To:
Roger Marks
Chair, IEEE 802.16 Working Group
r.b.marks@IEEE.ORG

Date: 28 August 2008

Subject: Liaison Statement to 802.16 on clarification and corrections to the IEEE 802.16 draft standard needed to support WiMAX certification.

**WiMAX Forum® Mobile Recommended Practice
Document
RPD for HARQ ACK region allocation**

Figure 229c—HARQ downlink allocation

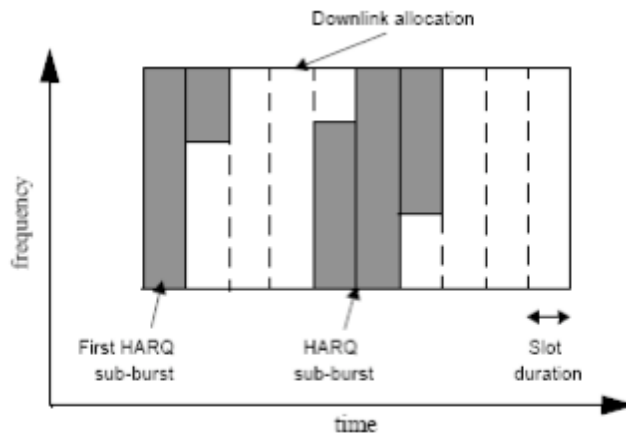
Moreover, for the downlink, HARQ ACK disabled/enabled burst is assigned with 1D allocation as shown in Figure 229c of the standard, which may not have a rectangular shape but may have a snake-shape, while the normal(non-HARQ) burst allocated with normal DL_MAP_IE is always allocated with rectangular shape(2D).

Thus, it means that when we talk about the maximum burst capability of HARQ ACK enabled/disabled burst in PHY level, we are talking about the capability to decode or encode bursts having CRC-16 attached with 1D allocation in downlink and to encode bursts with attaching CRC-16 in uplink. Generally, CRC-16 will be decoded and/or encoded in the hardware, while the CRC-32 attached at the PDU will be related to the software.

The HARQ ACK disabled burst allocated with HARQ_DL_MAP_IE with “ACK disable”=1 or HARQ_UL_MAP_IE with “ACK disable”=1 should be treated as a HARQ burst (Option 1) or a non-HARQ burst (Option 2) when counting the number of DL/UL bursts per frame per MS.

- Option 1 : Treat the HARQ ACK disabled burst as a HARQ burst (without retransmission) and count it accordingly as one HARQ burst when BS allocating bursts within the limitation of maximum bursts per frame per MS.
- Option 2 : Treat the HARQ ACK disabled burst as a normal(non-HARQ) burst and count it accordingly as one non-HARQ burst when BS allocating bursts within the limitation of maximum bursts per frame per MS.

The group recommends Option 2 as a remedy.
